### 10.3 Main Steam Supply System

The information in this subsection of the reference ABWR DCD, including all subsections, tables, and figures, is incorporated by reference with the following departures and supplements.

Figure 10.3-1 Main Steam Supply System

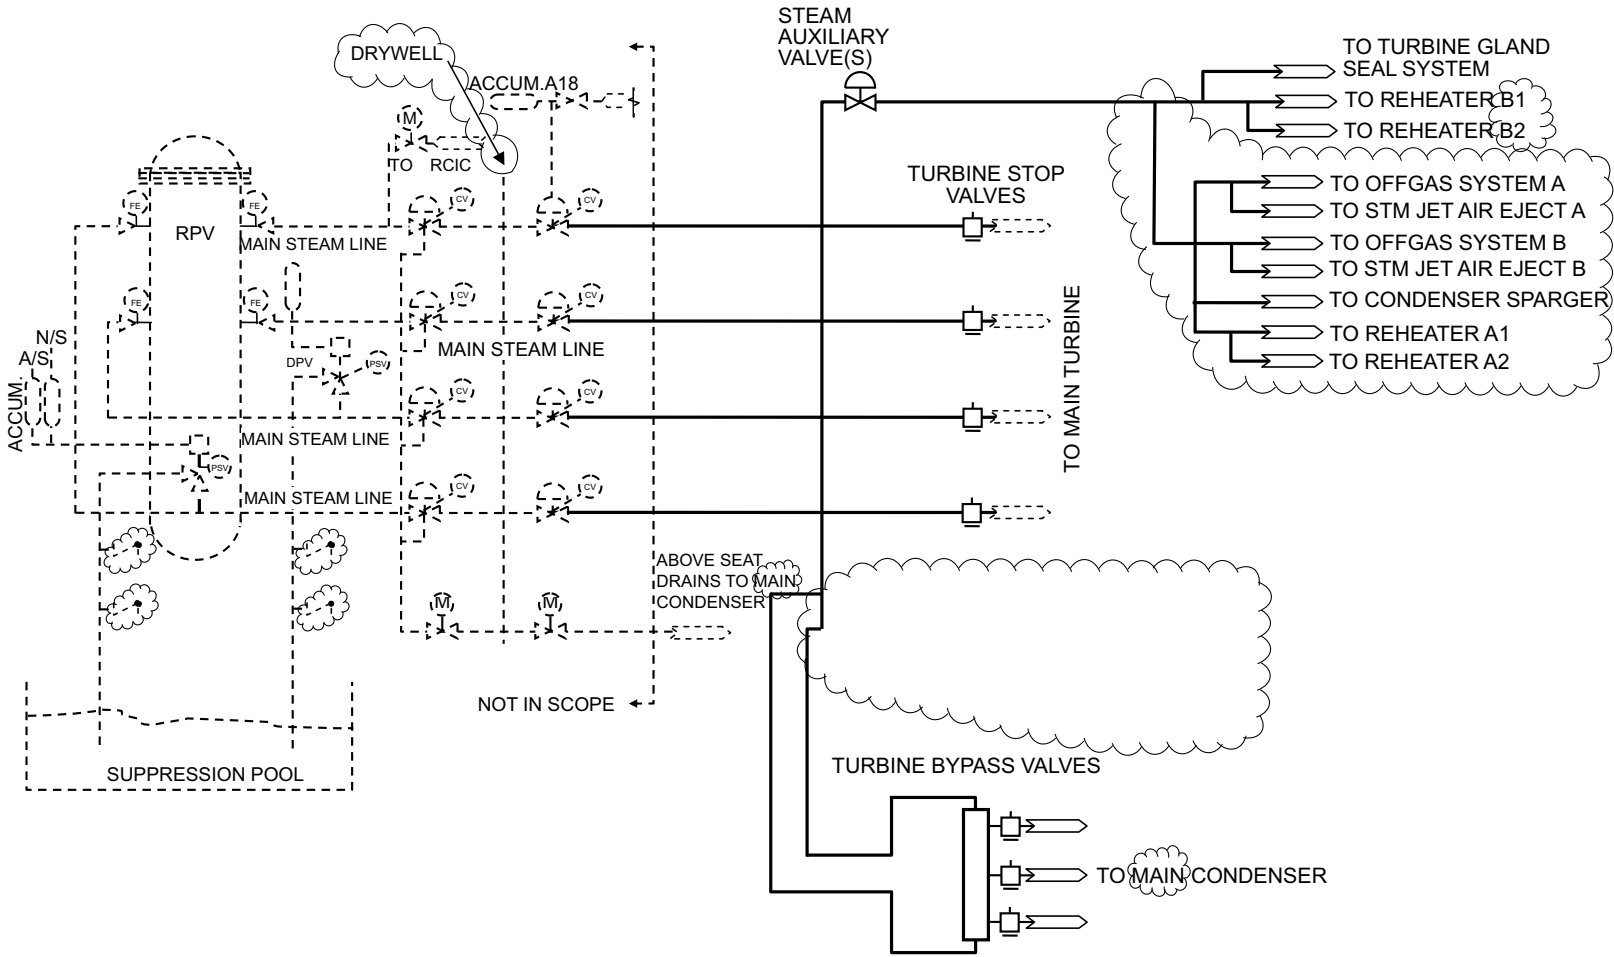
STP DEP 10.2-1 (Table 10.3-1, Figures 10.3-1 and 10.3-2)

*The Main Steam Supply System is illustrated in Figure 10.3-1. The system design data is provided in Table 10.3-1. The main steam piping consists of four 700A pipe size diameter lines from the outboard MSIVs to the main turbine stop valves. The four main steamlines are connected to a header upstream of the turbine stop valves to permit testing of these valves the MSIVs during plant operation with a minimum load reduction. This header arrangement is also provided to ensure that the turbine bypass and other main steam supplies are connected to operating steamlines and not to idle lines. The main steam process downstream of the turbine stop valves is illustrated in Figure 10.3-2.*

Figure 10.3-2 Main Steam Turbine System

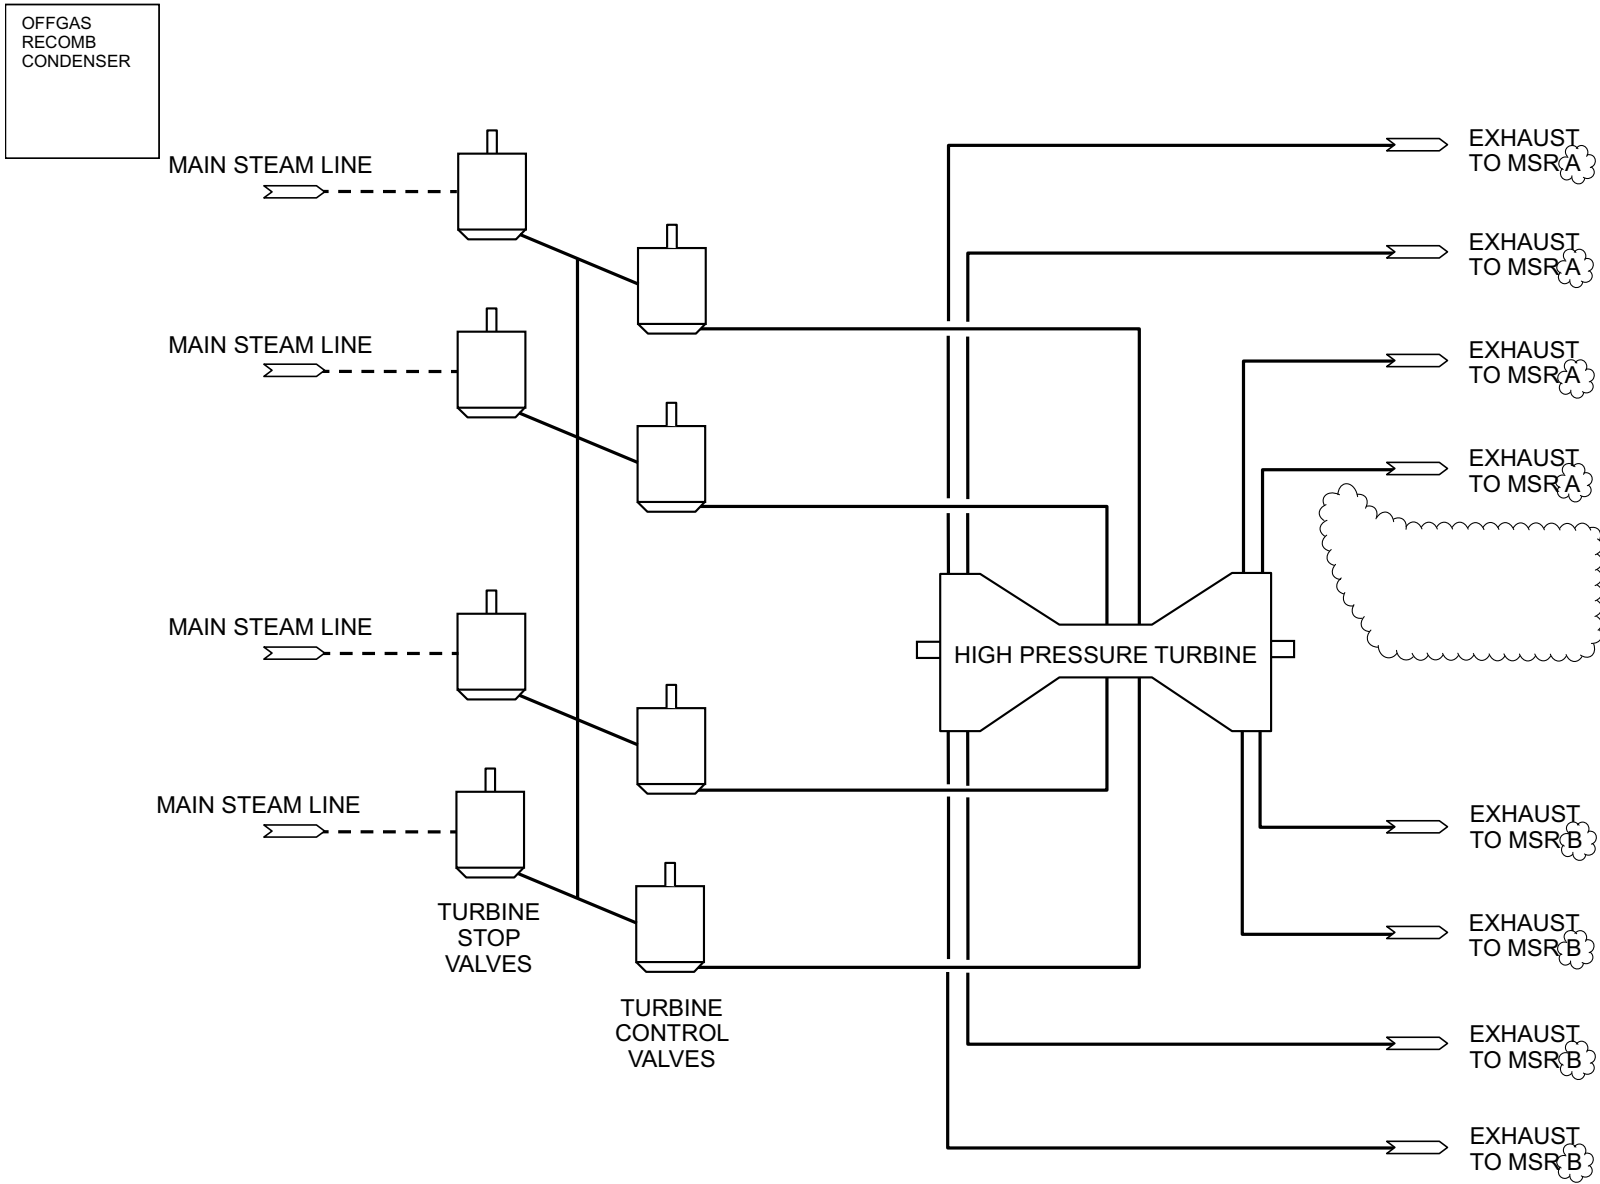
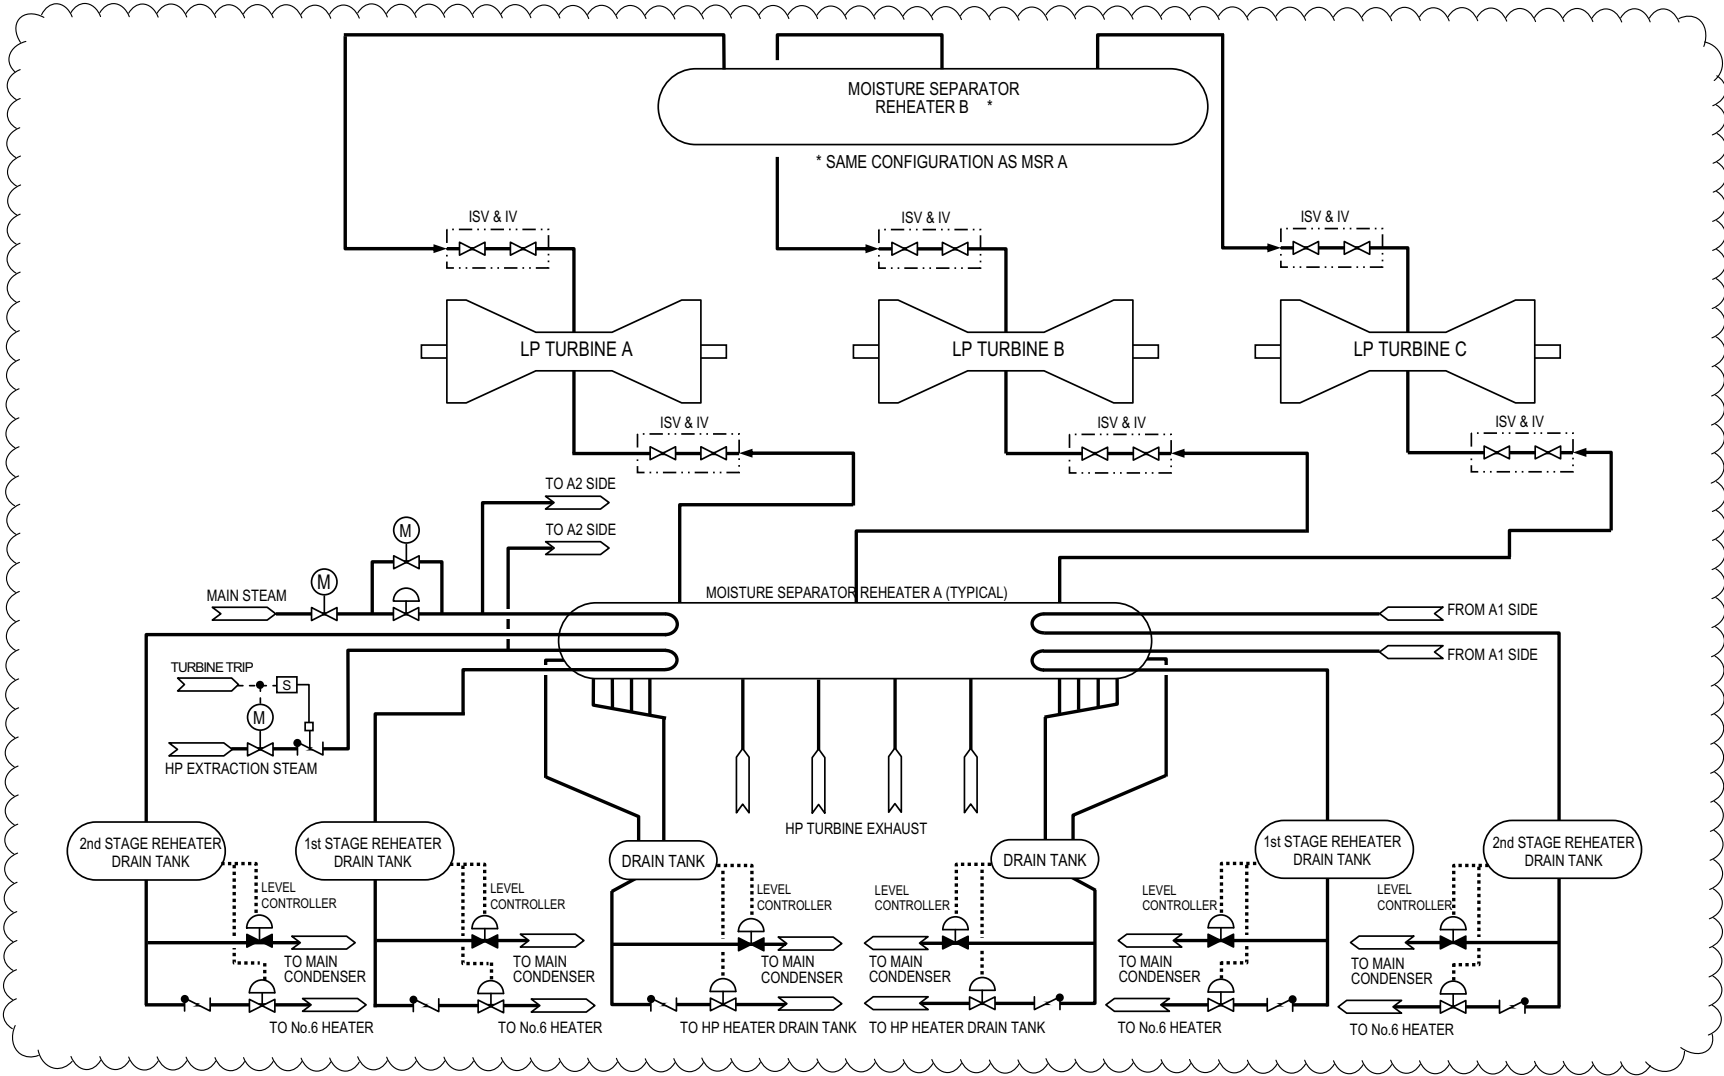
STP DEP 10.4-3 (Figure 10.3-2)
